Model: GP605 Series

Ref. No. : FF-T01-K1-000079-01

Location: ADF Frame Assembly

Subject: Improvement of Durability of ADF Hinge

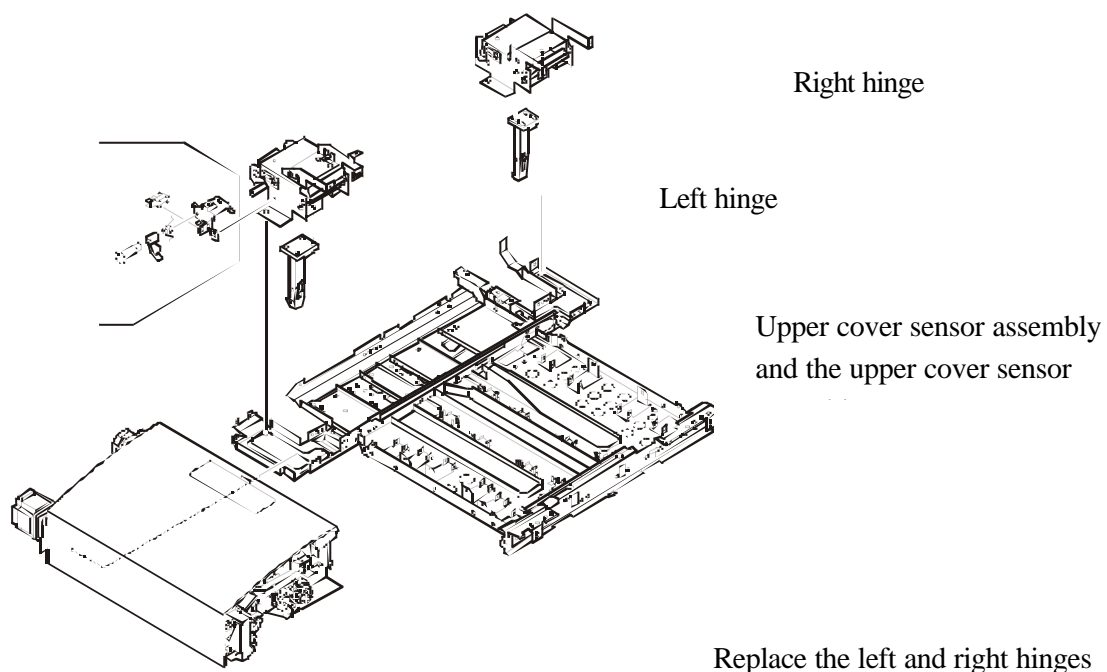
Reason: Aged ADF hinges may fail to keep the ADF in opened state. To avoid this, the hinges will be changed to the more durable ones used for DADF-J1.

The ADF fails to stay open and falls on the main body.

Aging of ADF hinges

The left and right hinges and the upper cover sensor assembly of the ADF will be changed to the ones used for DADF-J1.

When replacing the GP605 hinges with DADF-J1 hinges, be sure to replace the left and right hinges and the upper cover sensor assembly at the same time. If the GP605 parts and the DADF-J1 parts are mixed, the ADF will not shut properly and causes troubles such as paper jam.
